**SWIMMING RIVER
RESERVOIR
NJ 00082**

**PHASE 1 INSPECTION REPORT
NATIONAL DAM SAFETY PROGRAM**

Philadelphia District
Corps of Engineers
Philadelphia, Pennsylvania

March, 1979

View of erosion behind left wingwall

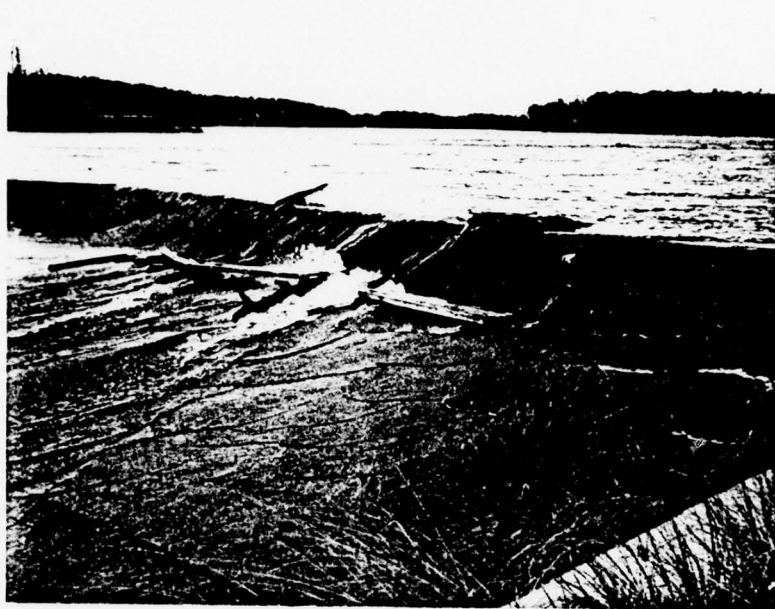
Slight erosion (see page 2).	Superficial erosion where sheet runoff from concrete slab meets left earth embankment.
Severe erosion behind foot of right and left wingwalls.	Should be filled to existing slope of embankment.

It is suggested that the eroded areas behind the spillway wings at the top and bottom of the wasteway be backfilled with stone and/or ditch slope protection. Additionally, the minor erosion pockets at the back slopes on the northerly embankment dike be backfilled and replanted. The owner might consider investigation into supplying a different type of ground cover (similar possibly to crown vetch) which would better take hold on the steep dry slopes.
